Town of Maynard

January 13, 2026 Planning Board Meeting

2. Public Hearing - 151 Main Street (Continued From December 9, 2025)

Peer Review Comment Form

UTILITY PLAN
FOR: MATTHEW HALL
SCALE: 1"=20'
OCTOBER 9, 2025
REVISED: DEC 4, 2025

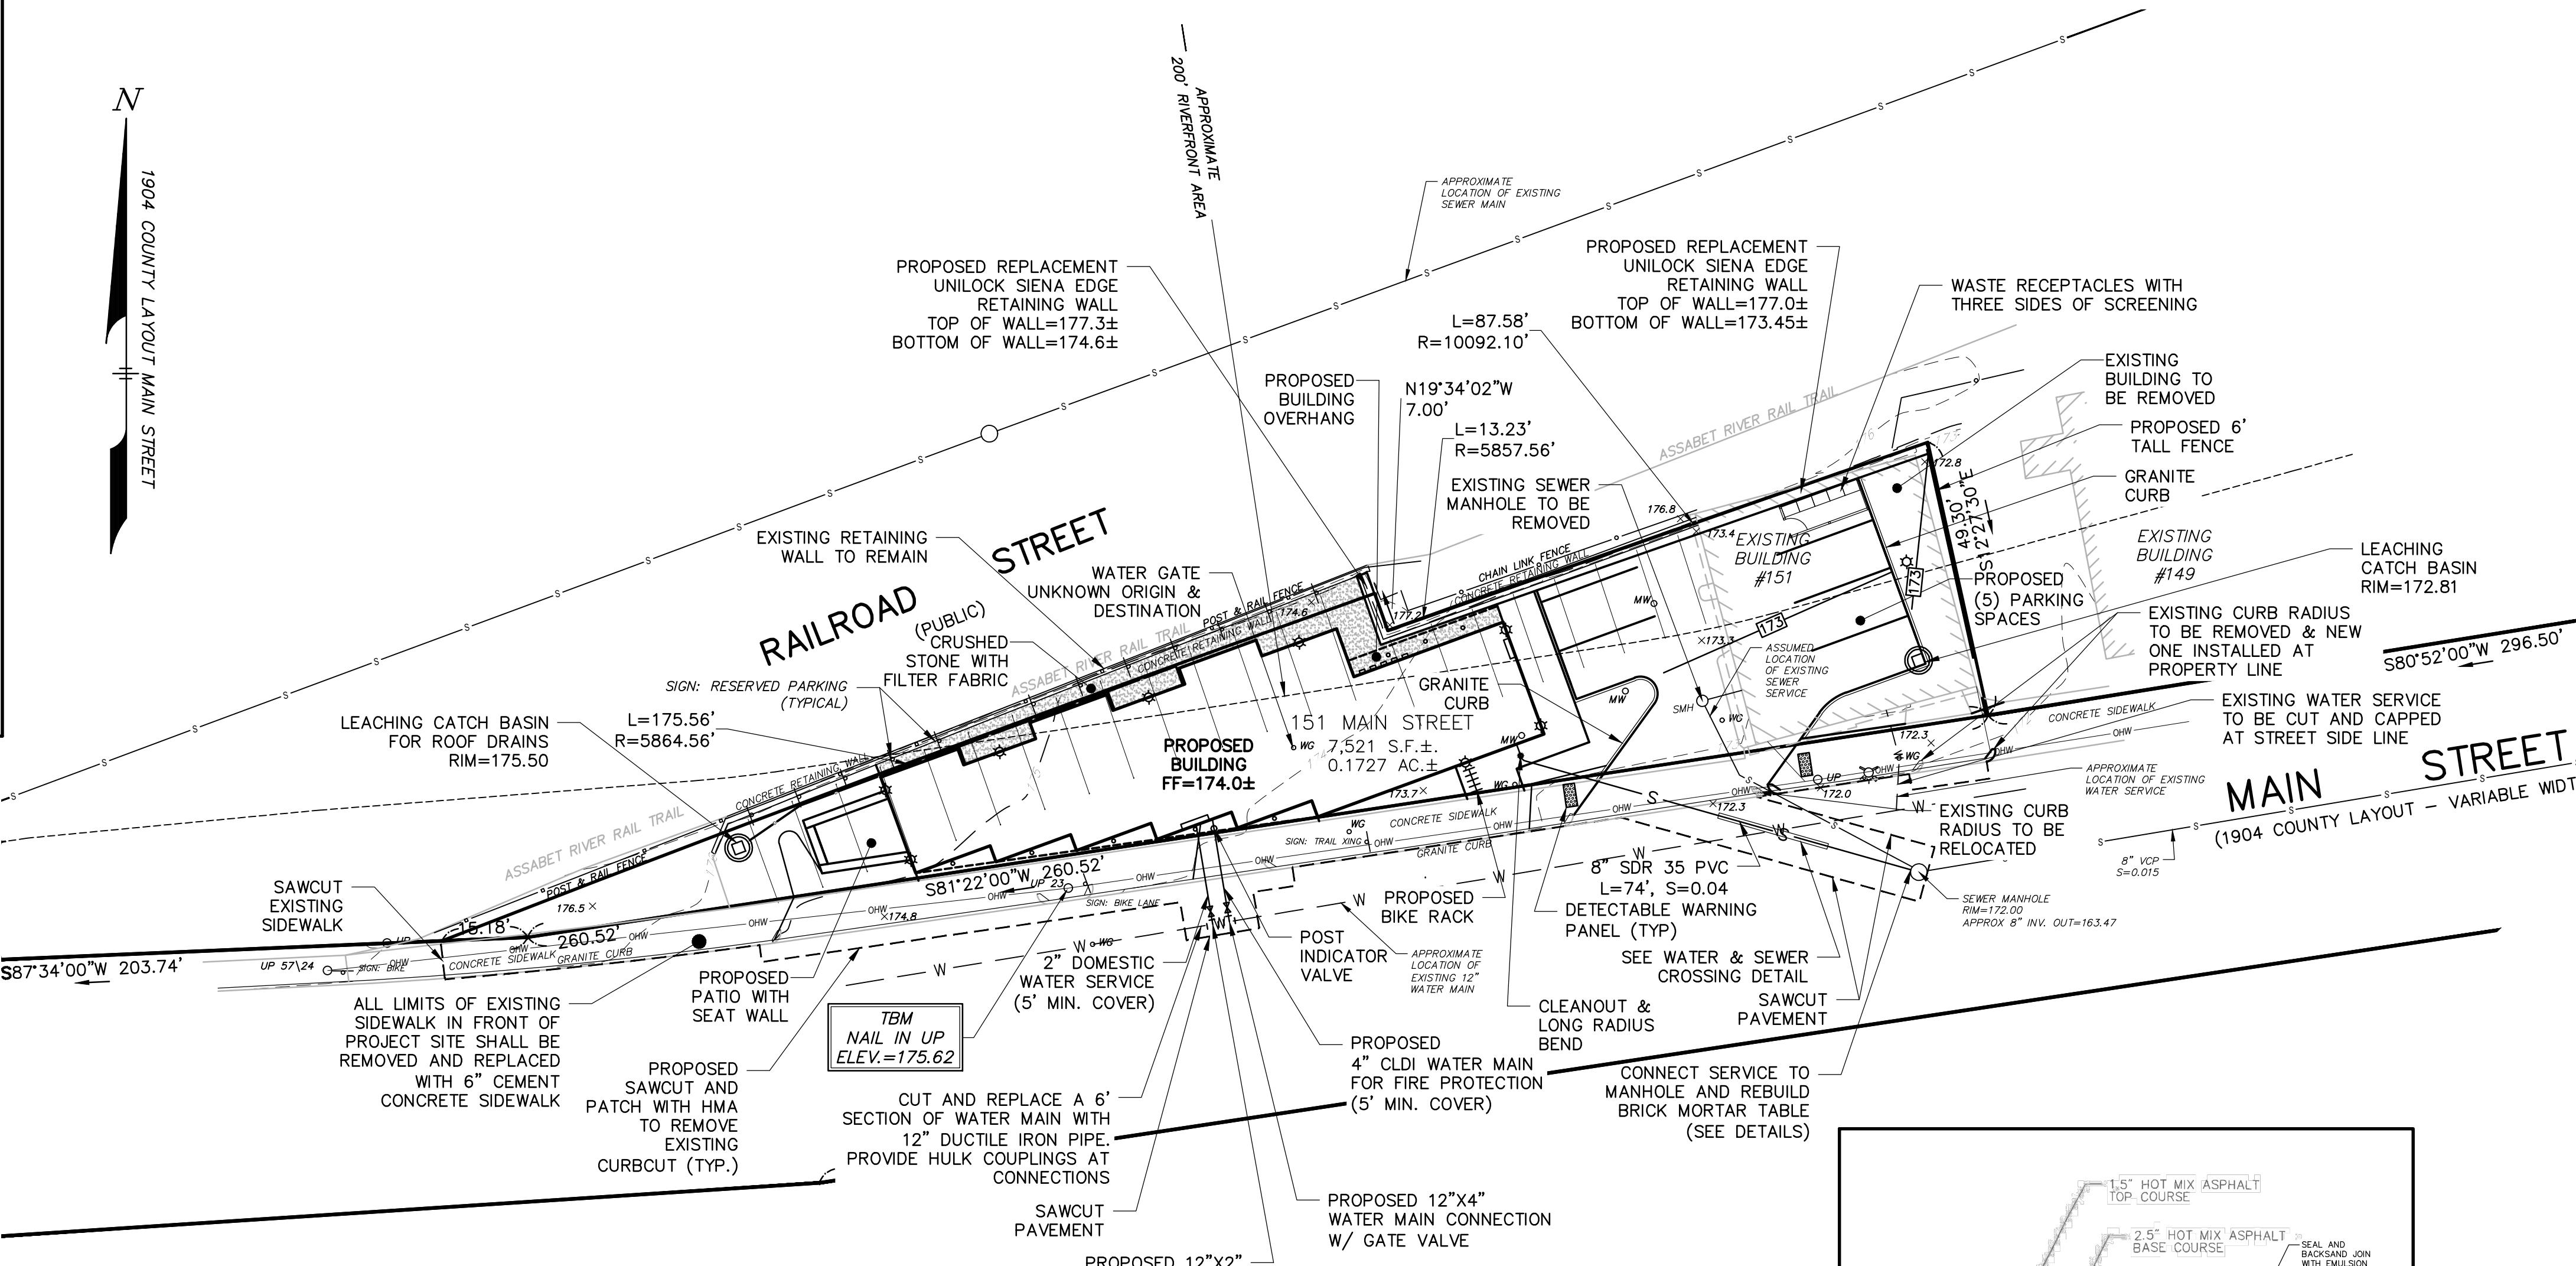
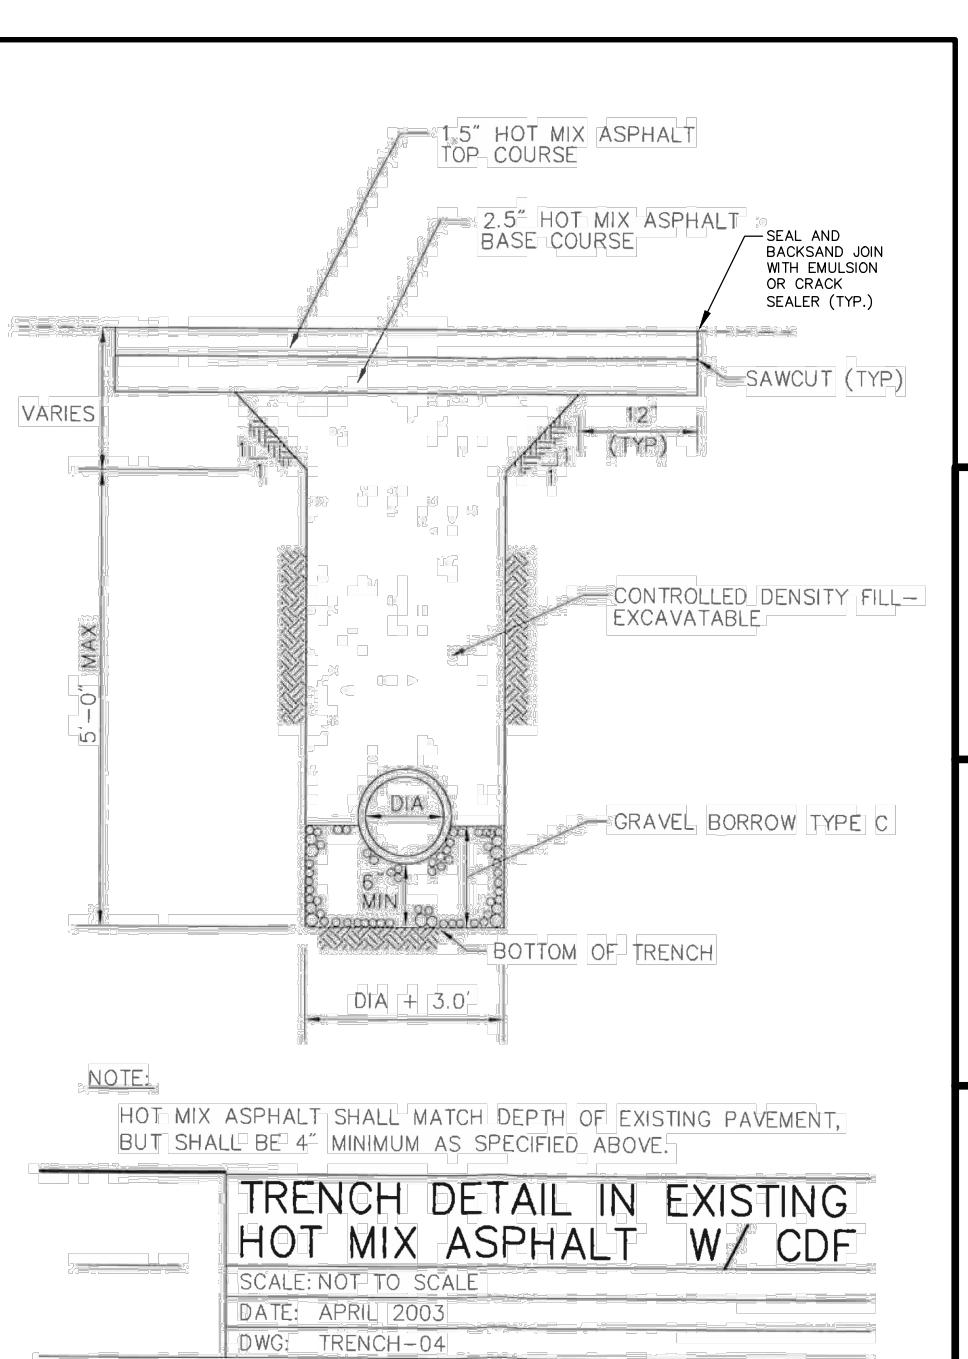
14	Utility Plan	PB Rules & Regs C.9	Has a system capacity analysis been performed and submitted to the DPW?	The DPW has confirmed adequate capacity for this project in terms of water demand.		
14A	Utility Plan	PB Rules & Regs C.9	We defer to the DPW for approval.			
15	Utility Plan	PB Rules & Regs H.3	Has the project been reviewed by the Fire Department to confirm how fire alarm and terminal boxes shall be installed and for fire access to the site?	The fire alarm and terminal box layout has not yet been finalized but will be coordinated with the Maynard Fire Department.

NO.	SHEET NO.	SECTION	GREEN'S COMMENT	Applicant's RESPONSE	CONFIRMED BY	DATE
15A	Utility Plan	PB Rules & Regs H.3	We recommend this be made a condition of approval.			
16	Utility Plan		The WATER MAIN CONNECTION DETAIL shows both an 8" and a 12" existing water main, please clarify. This also only seems to be a detail for the fire protection line, please revise or provide additional detail to also show the 2" domestic service. Also, the plan indicates a cut in tee but the detail indicates a tapping sleeve and valve. Please confirm with the DPW on the preferred connection.	The detail has been corrected to note the water main as 12". The detail has also been added to say "or 2" domestic".		
16A	Utility Plan		We defer to the DPW for approval.			
17	Utility Plan		Have test pits been performed to confirm soils are suitable for infiltration and the seasonal high groundwater is at least 2' below the bottom of the leaching basin? The soil onsite is potentially contaminated. Have soil sampling been performed to confirm the contamination of the soil is ok for infiltration BMPs? This should be sampled and confirmed by an Licensed Site Professional (LSP).	No, site is covered by Building and paving. Construction of the rail trail at the west corner did not encounter contaminants.	JT	12/23/2025

17A	Utility Plan		Based on the Planning Board Hearing, the Engineer is responsible for confirming the leaching basin has adequate separation to groundwater so, the BMP will function properly.		JT	12/23/2025
18	Utility Plan		WATER & SEWER CROSSING DETAIL the detail does not match what is shown in the plan. In the detail, the water main has the sleeve, but in the plans the sewer has a sleeve. Typically the sewer is encased at the crossings. Please clarify.	The detail has been corrected with the water and sewer pipe labels swapped to accurately reflect how the sewer line is proposed to be encased at the water crossing.	VR	12/9/2025
19	Utility Plan		How will the sewer manhole and pipe be abandoned? Will it filled and plugged at the active manhole?	The DPW has requested that the sewer manhole be removed. The pipe can be abandoned in place or removed from site if encountered during construction.	JT	12/23/2025

20	Utility Plan		It is not recommended to have an infiltration BMP such as the leaching basin within 10 feet of a building even if it is on a slab foundation. Please consider revising.	The leaching catch basin behind the proposed building has been removed.	VR	12/9/2025
21	Utility Plan		A detail for the crushed stone in the rear of the building should be provided. It is unclear from the grading, is this area able to drain out to the east behind the building?	Added a dispersion trench detail for the rear of building, surface flow graded to drain out	VR	12/10/2025
22	Stormwater Pollution Prevention Plan		Please indicate on the plans where each erosion control measure is being proposed.	Sheet 6 of the plan set shows a construction fence around the whole area of work, except for where a siltation barrier is proposed along the eastern edge of the project. Most of the site is downgradient of the neighboring areas except for this eastern portion. Additionally, silt sacks are proposed within the on-site proposed catch basins as well as in the existing catch basin between #145 and #147 Main Street (label with arrow on plan).	JT	12/23/2025

1 PLANTING PLAN

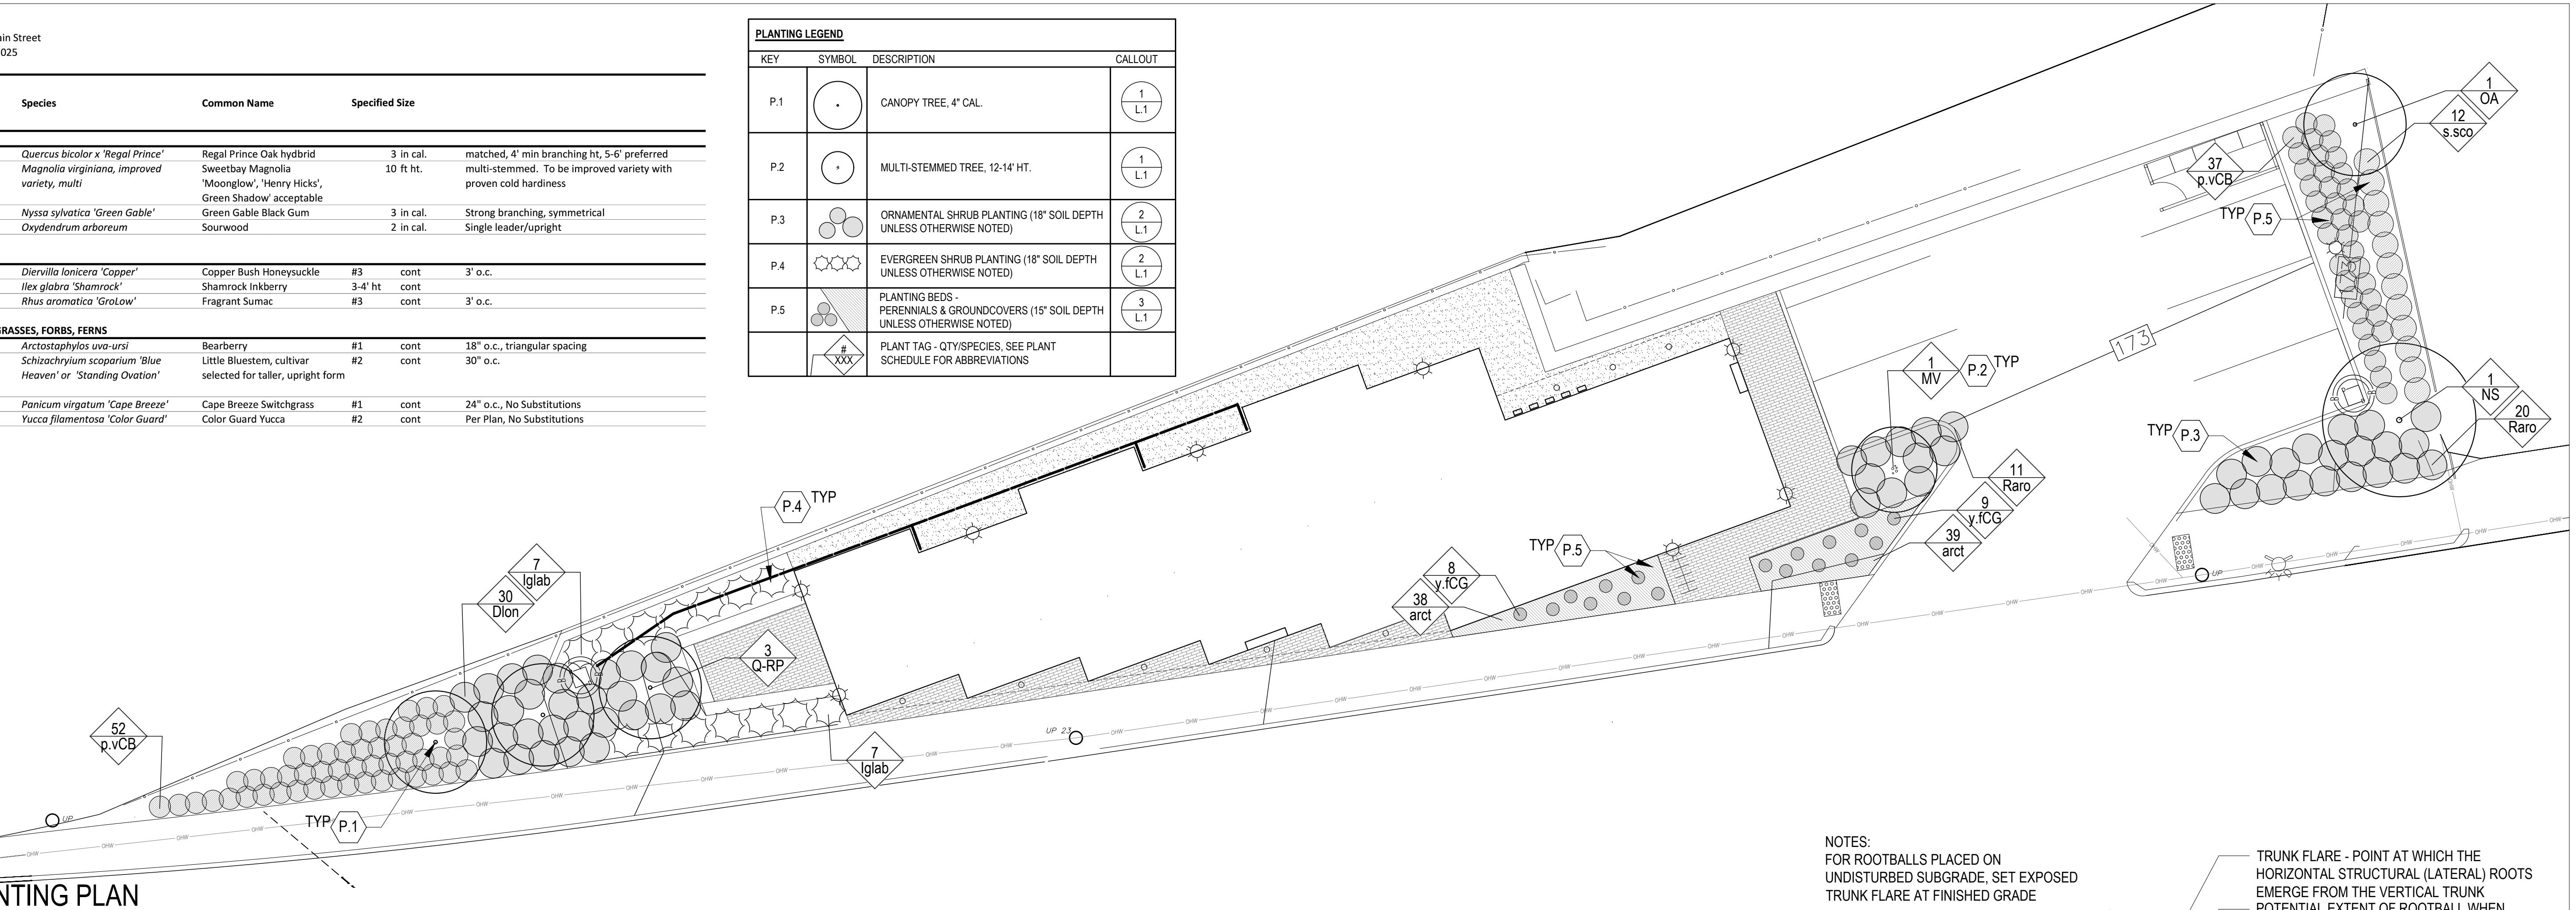
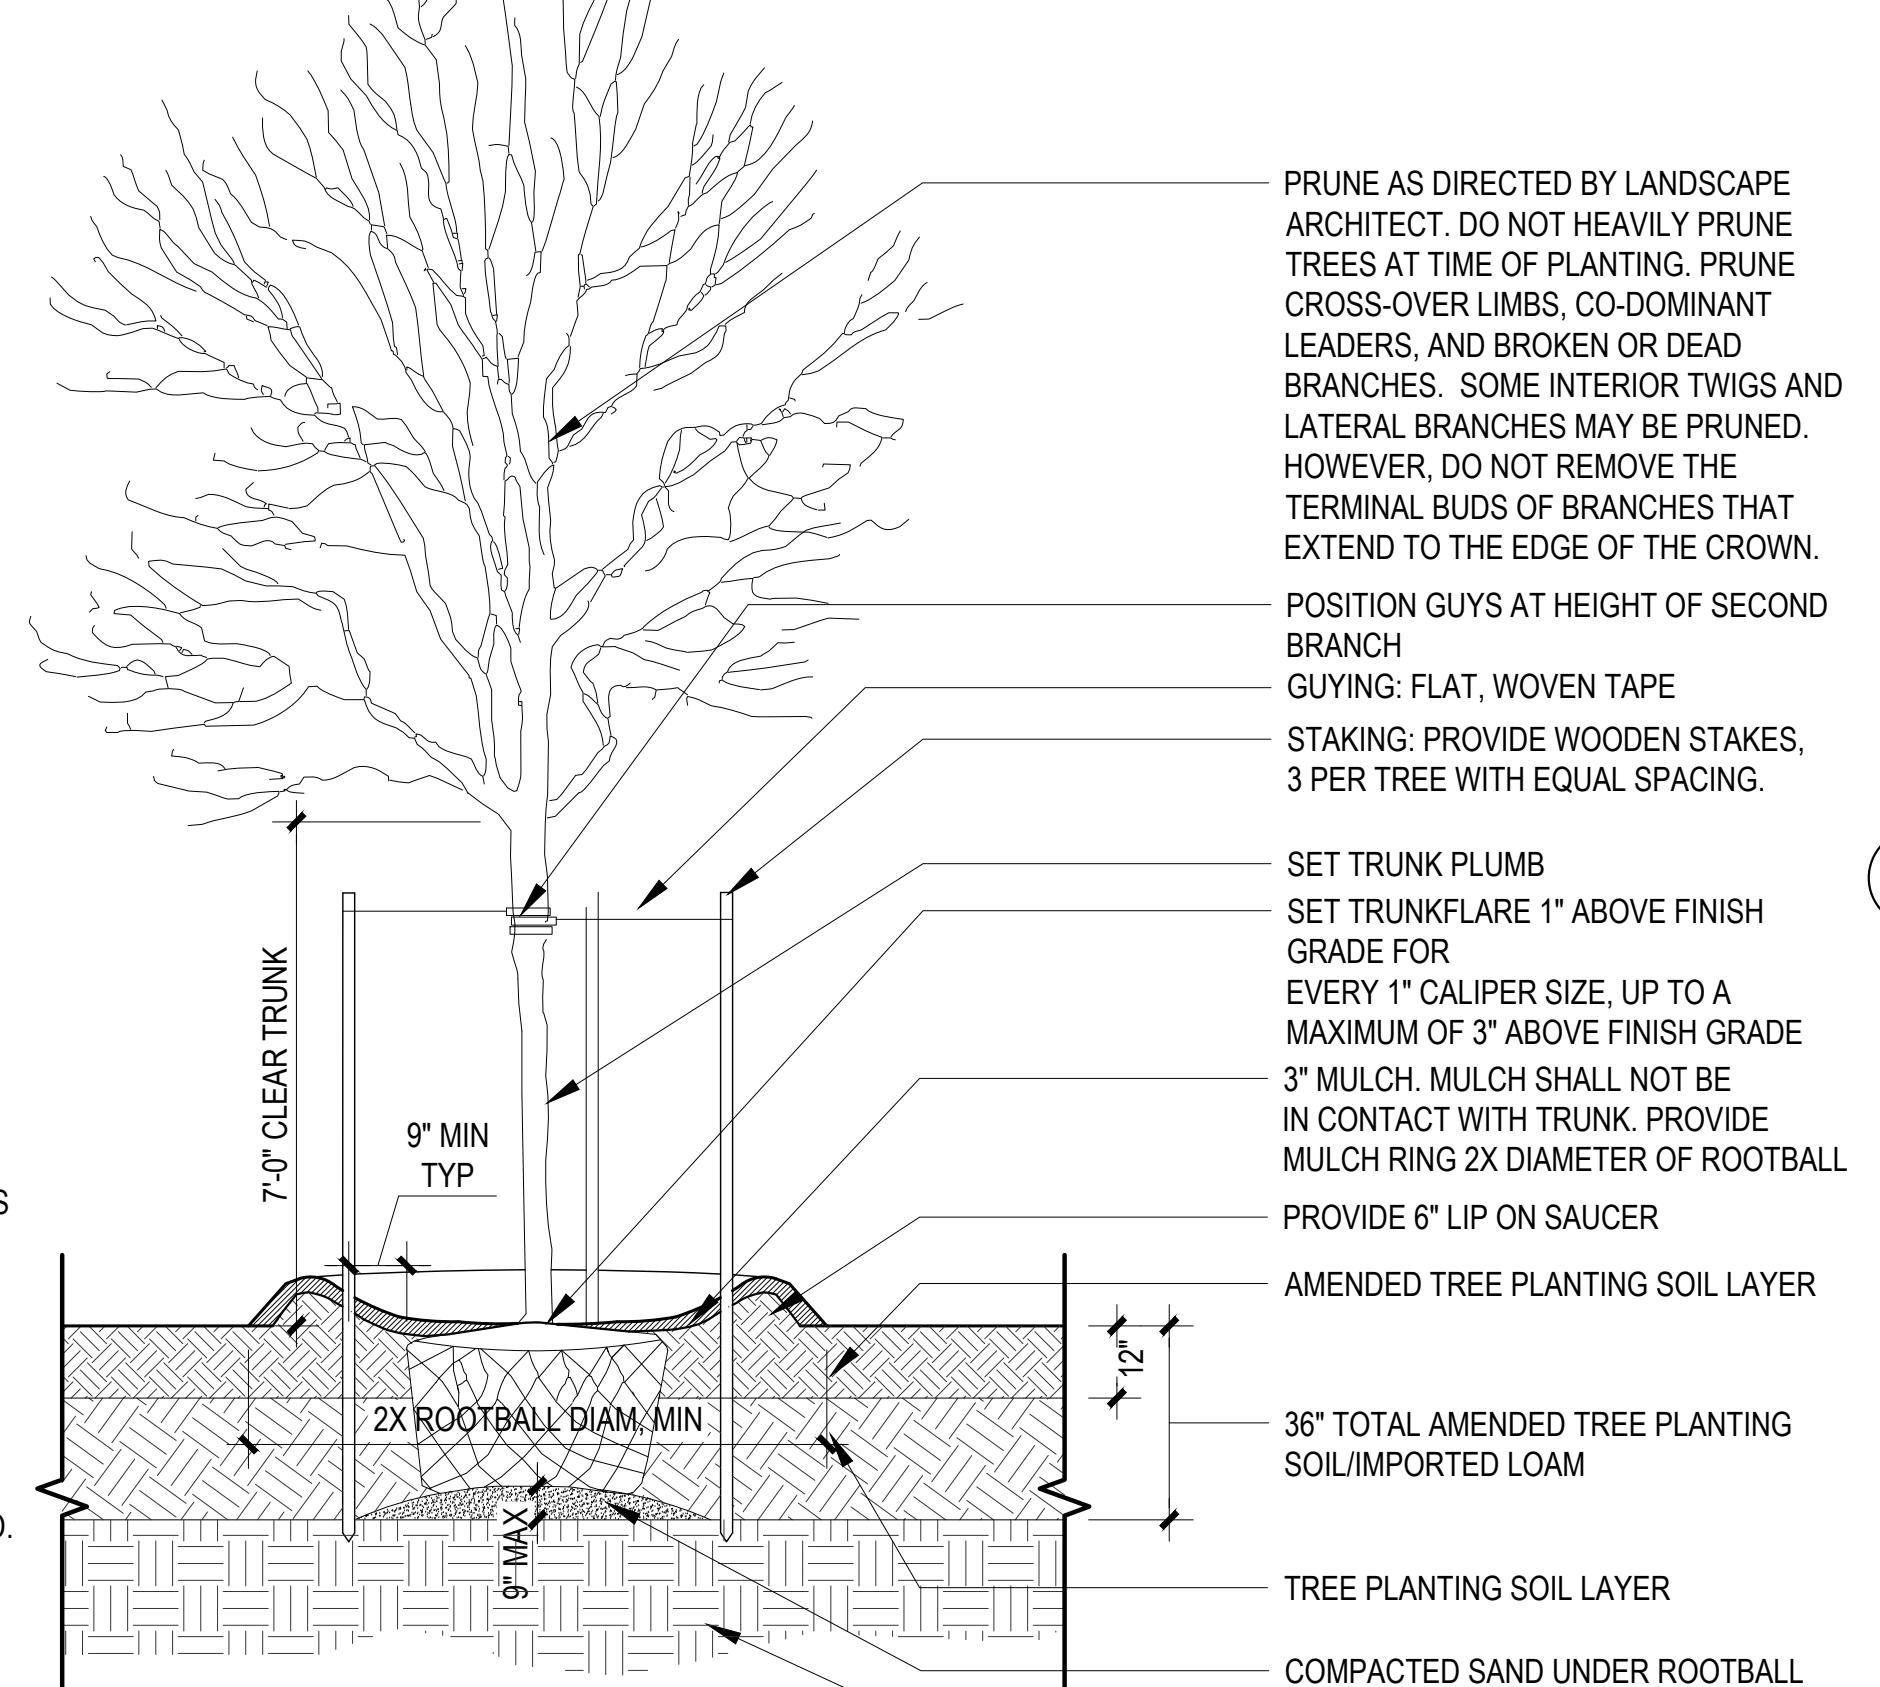
27	Landscape Plan	PB Landscape Regs 5.6.3	A fence is required in locations where a vegetative buffer is not practical. Please revise.	See revised plans	JT	12/23/2025
28	Landscape Plan	PB Landscape Regs 5.6.4	Trash receptacles are shown. There is a requirement for screening. Please provide details of trash enclosures or whatever screening is possible.	We have changed from trash lockers to conventional totes with screening.		
28A	Landscape Plan	PB Landscape Regs 5.6.4	We defer to the Board for approval.			
29	Photometric Plan	PB Landscape Regs 5.9.2	Details for the lighting proposed was not provided. Please confirm the fixtures are dark sky compliant and the heights meet the Maynard PB Landscape Regs. Please confirm the light fixtures have zero uplight or are fully shielded.	Lighting cuts for fixtures used in photometric plan have been provided, see PB comments regarding light levels at entries.	JT	12/23/2025
